Architect's Field Report - Warranty Walk

18 October 2022

18056-Warren Central Junior High School / Warranty Walk

Figure 2 – Leak at E end of Addition

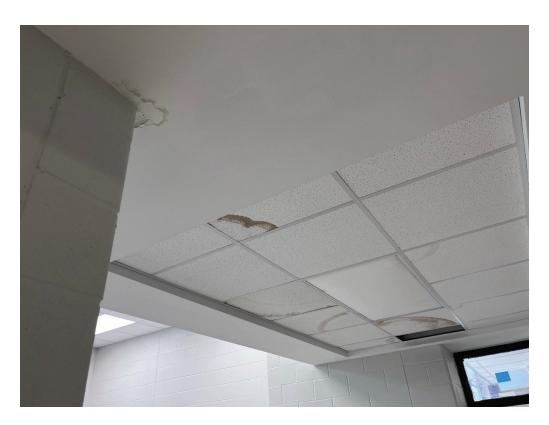
The connection between the addition and the existing school have had several leaks. These were noted during construction and were repaired,

but have since opened up again. Throughout the connection on the east and west ends, water is infiltrating the space through the roof. This should be repaired by the contractor through their basic warranty.

Figure 5 – Door Installed with Bare Wood

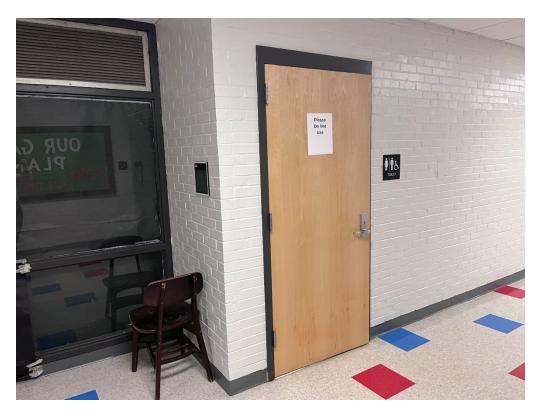
There was door installed in the 2^{nd} floor administrative area that was

never finished. It is bare wood. This should be finished.
